EXHIBIT E**Tree Preservation Plan**

Re: Green Mountain Planned Residential Development and Phase 1 Response to WDFW
Comments

RE: Follow-up to Comments on Green Mountain Planned Residential Development

Figure 2
OAK MITIGATION DETAILS
Green Mountain Mixed Use PRD - Phase 1
Green Mountain Land, LLC
City of Camas, Clark County, Washington
Section 20, Township 2N, Range 3E, W.M.

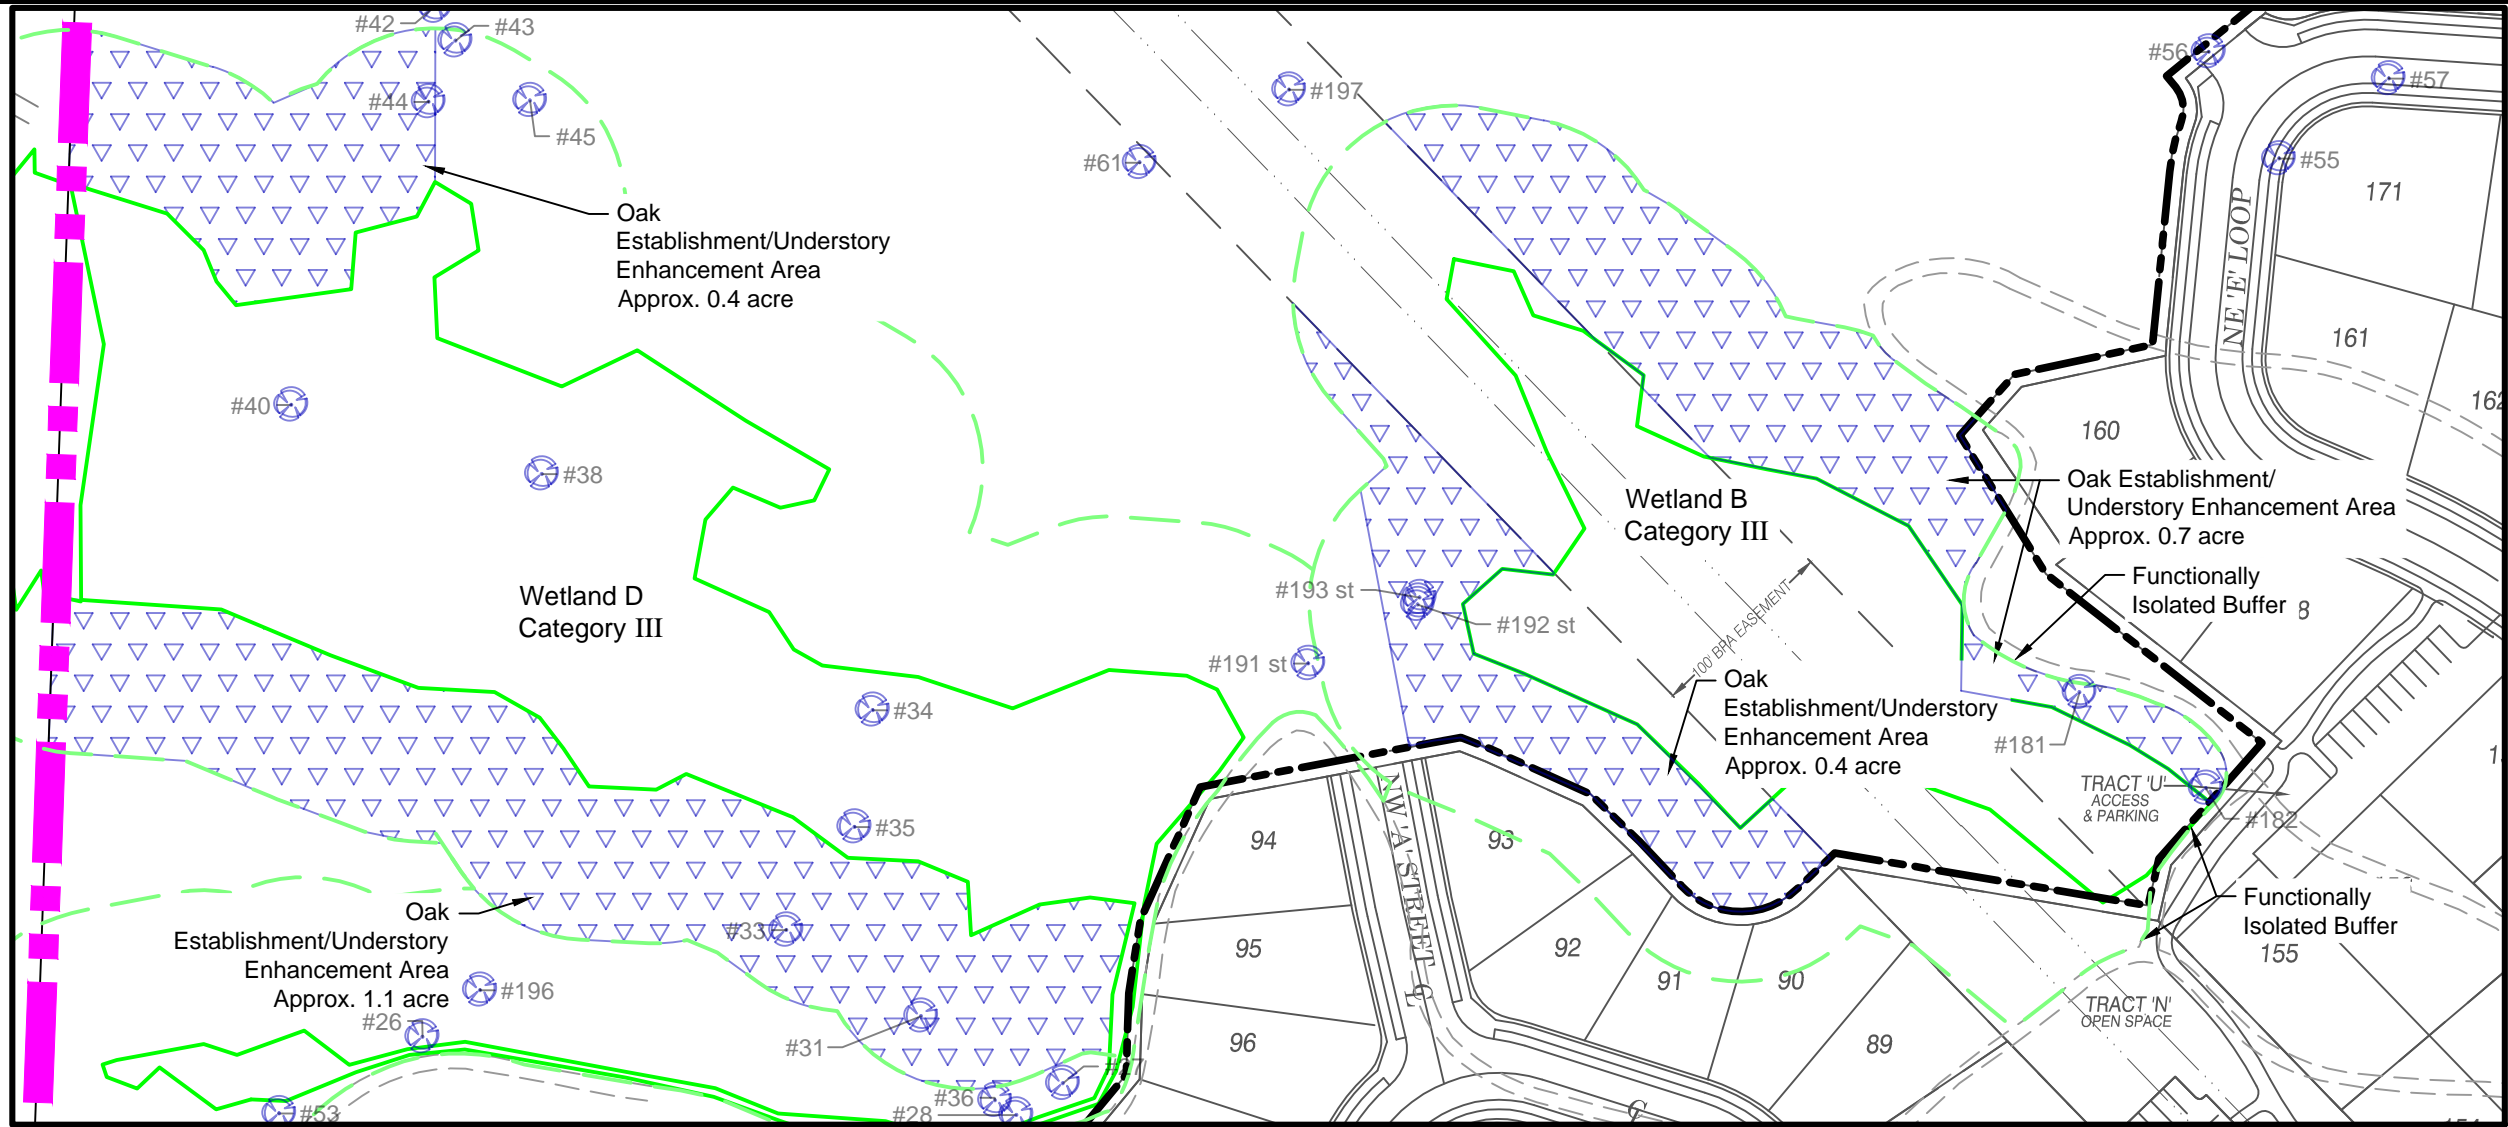
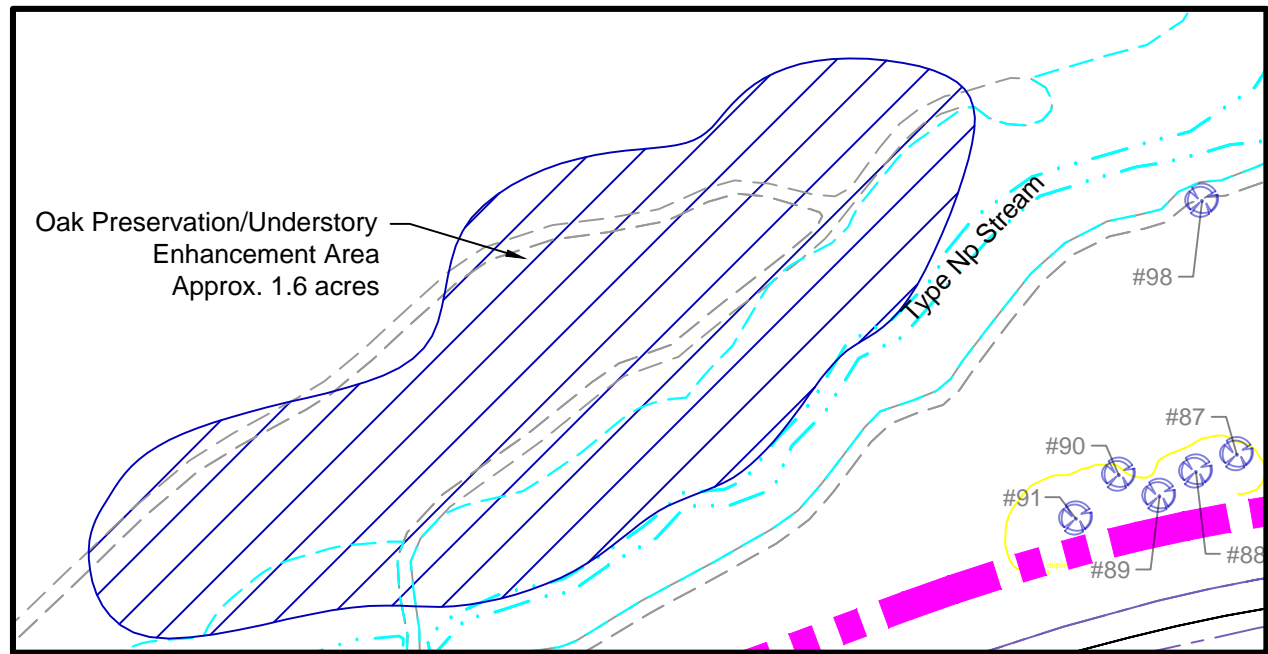
The approximately 6,500 square foot (0.15 acre) oak planting area that was originally proposed in the southern buffer of Wetland D³ will be expanded to accommodate additional area for planting trees and shrubs appropriate for western Washington oak woodlands. Figure 2 shows potential oak mitigation areas in the buffers of Wetlands B and D that set aside a larger area for mitigation than is actually needed (Exhibit B). The precise planting area will be determined at a later date pending further analysis of ecological and site layout considerations. Any extra area not used for the Phase 1 mitigation may be used for advance mitigation for the subsequent phases.

The oak preservation/enhancement area is proposed to compensate for 50 percent of the oak canopy impacts by setting aside existing oak habitat along a riparian corridor in the southern PRD (Table 2; Exhibits A and B). The exact boundaries of this mitigation area shown on Figure 2 are to be determined pending ecological and site design considerations. The oak preservation/enhancement area will mitigate for temporal loss, protect oak habitat, and enhance the understory with native shrubs commonly associated with oak woodlands. To enhance species diversity and habitat structure, native shrubs will be installed in selected portions of the understory that are more open and will benefit from an understory stratum.

The Oregon white oak mitigation strategy presented in the May 5, 2015, ELS letter will, over time, replace the oak habitat removed for Phase 1. The methods of calculation, ratios applied, and targeted tree densities are consistent with suggestions made by WDFW. The strategy provides opportunity to determine some of the details of implementation at a later date; WDFW would greatly appreciate being a party to those future planning efforts.
